HI-STORM 100 LAR 1014-5 RAIs #2 Responses

Holtec International
June 28, 2006

RAI 2-1

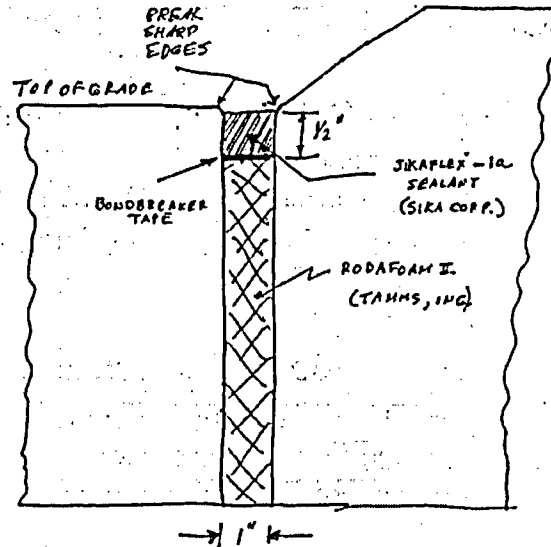
- 2-1 Details of joint between top pad and transporter riding surface
 - Details are added to Licensing Drawing 4501
- 2-2 Visual Inspection of caulking around the CEC
 - Visual surveillance requirements are already specified in Table 9.1.1 of Supplement 9.1. They require annual surveillance of the interface

Expanded Representative Simulation (MPC Lid removed for clarity)

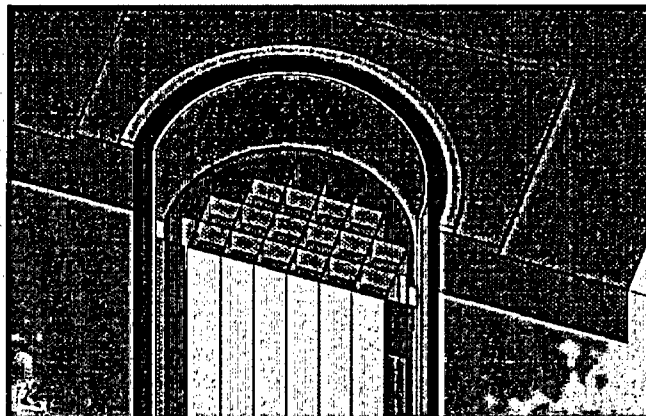
- 3-4, 3-7, 3-8, 3-11, 3-13
 - Holtec is revising FSAR and TS to ensure that every site owner shall perform a site specific analysis using the methodology set forth in the FSAR and used in the representative solutions presented in the FSAR. All inferences that the site owner can opt to demonstrate that the representative solutions are bounding (and therefore, no new solution must be performed) are being removed from the TS.
 - The representative solution in the FSAR will be the solution already presented with the addition of the divider shell, the MPC upper and lower guides, the MPC, the fuel basket, and fuel in each cell. The MPC-32 will be the representative MPC and all nominal gaps will be simulated.

- 3-4, 3-7, 3-8, 3-11, 3-13 (cont.)
 - The top-of-foundation is still driven and is assumed to be bedrock (no flexibility); one VVM is considered; the lid is included with the correct load path and mass modeled. SINCE THIS IS TO REPRESENT A TYPICAL SOLUTION SOLELY TO PROVIDE AN APPLICATION OF THE METHODOLOGY, NO EVALUATION OF THE EFFECT OF MULTIPLE VVM'S, FLEXIBLE PAD, EXTENT OF SURROUNDING SUBSTRATE, SUBSTRATE UNDER PAD DOWN TO BEDROCK IS INCLUDED. The applicable methodology is spelled out in the written response to RAIs 3-4 and 3-7, and is to be put in the FSAR, and specifically referred to in the TS.
